# Old Police Station

## Town of Freetown ADA Transition Plan

May 2023

Institute for Human Centered Design

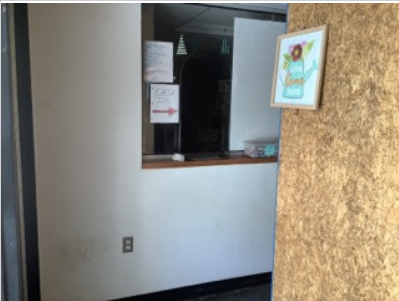
ID	Location	Floor	Room	Element	Type	Photo	Issues	Current Measure	Recommendations	Quantity	Price	Cost Estimation
6	Racks Near North Side Parking Lot	Ext.		Exterior Access Route	Exterior		Accessible route not provided	-	Ensure an accessible route is provided food display racks.	1	-	\$0
Curb Ramp												
7	East Side Parking Lot	Ext.		Curb Ramp	N/A		Running slope is > 1:12 (8.33%)	10.6%	Reduce running slope to be no steeper than 1:12 (8.33%).	1	2800	\$2800
8	Curb Ramp Near North Side Parking Lot	Ext.		Curb Ramp	N/A		Landing not provided at top of curb ramp	-	Provide landing at top of curb ramp or reconfigure ramp.	1	2800	\$2800
Off-Street Parking Lot or Garage												
9	East Side Parking Lot	Ext.		Off-Street Parking Lot or Garage	Visitor		Total # of parking Total # of designated car accessible parking spaces Total # of designated van accessible spaces Running or cross slope at space > 1:50 (2.00%) Running or cross slope at access aisle > 1:50 (2.00%) Sign with the International Symbol of Acc. not provided Sign does not have the designation "Van Accessible" Sign bottom < 60" above finished grade Surface not stable, firm, and slip-resistant	15 2 0 5.5% 4.5% - - 47" -	Reduce running or cross slope at the spaces and aisle to be no steeper than 1:50 (2.00%). Provide a sign with the International Symbol of Accessibility (ISA) at each space with the bottom of the sign 60" min. above the ground and the top 96" max. above the ground. Add the designation "Van Accessible" to the sign located at the van accessible space. Repair surface.	1	1900	\$1900
